**Re: Broadway Industrial Center Lot 8 Grading and Drainage Plan,  
Engineer's stamp dated 10/29/02 (M15/D38)**

**Re: Broadway Industrial Center Lot 8, Engineer's stamp dated 10/29/02 (M15/D38)**

DATE: October 29, 2002  
SUBJECT: LOT 8, BROADWAY  
INDUSTRIAL CENTER

Graded Channel

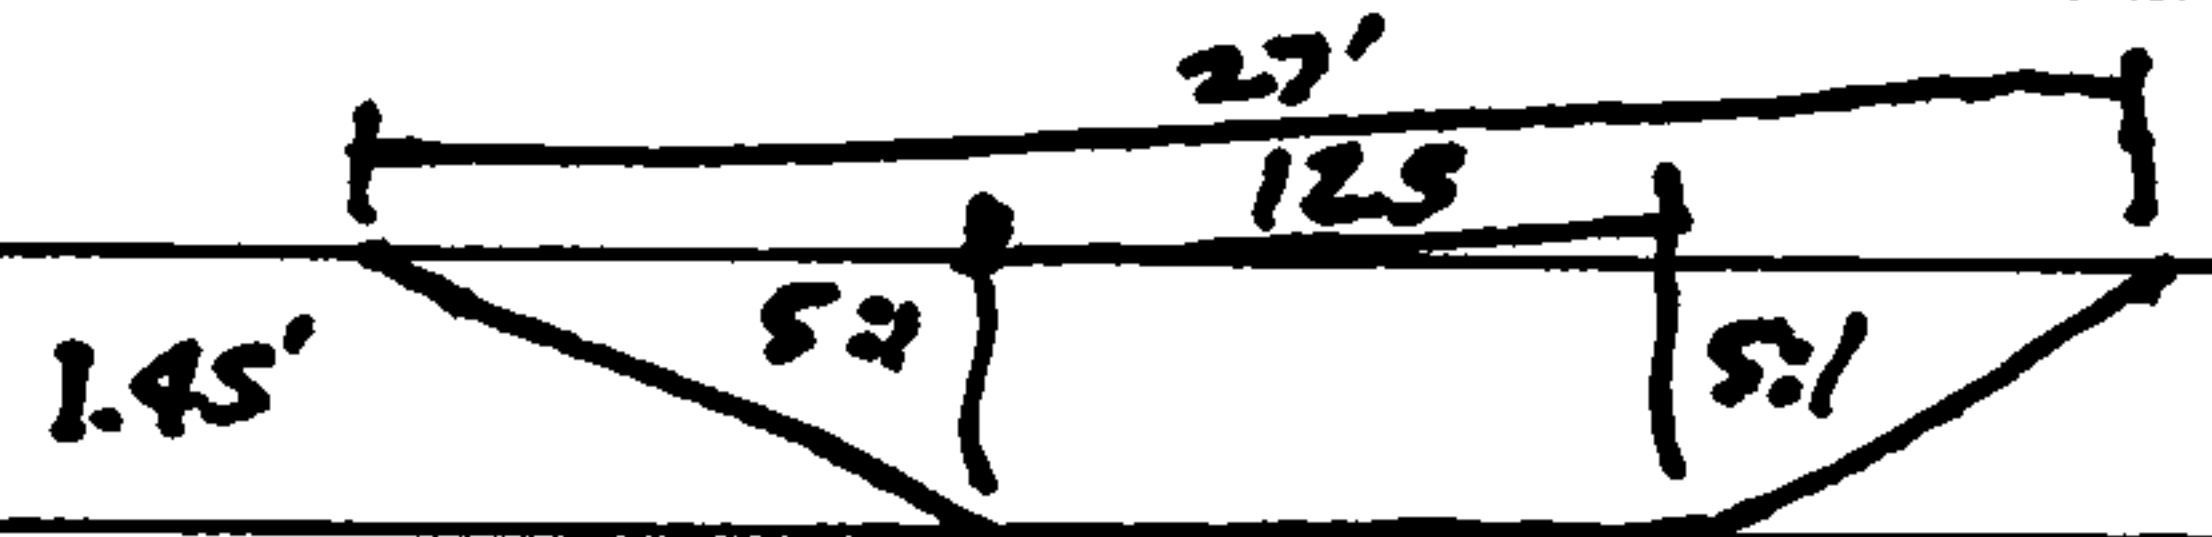
Design Q  
=  $Q_{100}$  ?

## WEIRS

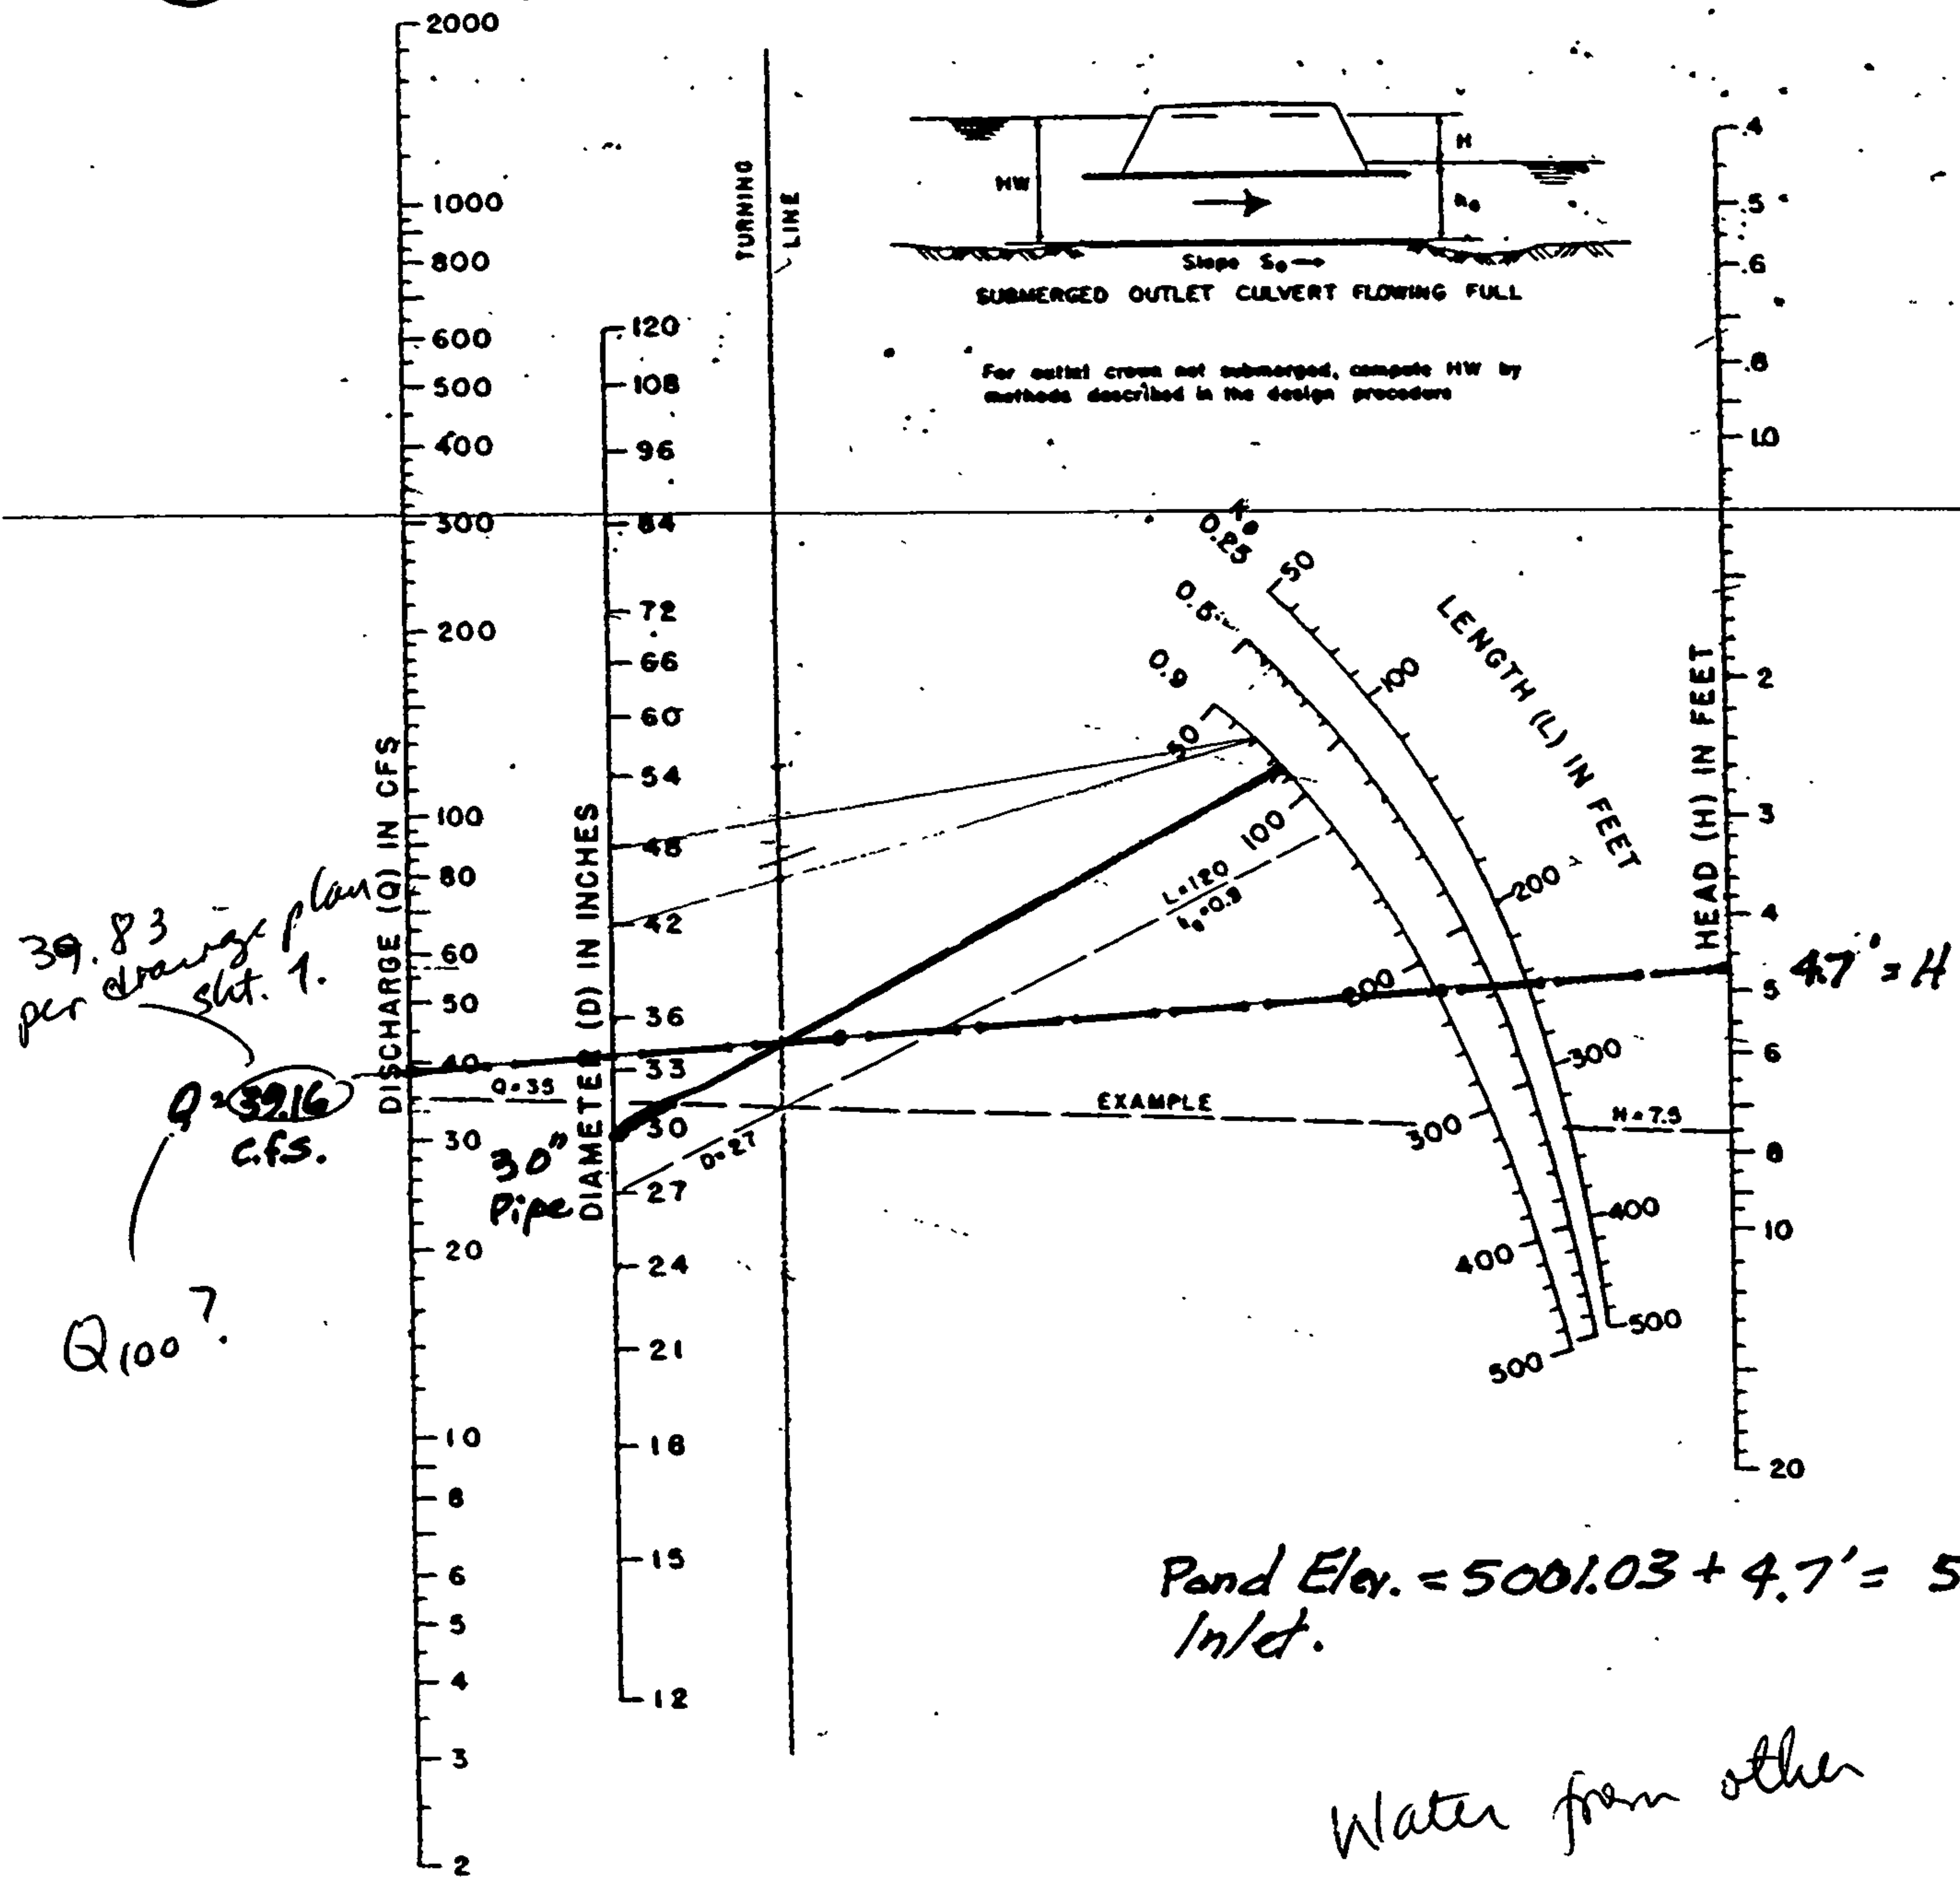
Water from other sites -  
What is pond's max WSEL?
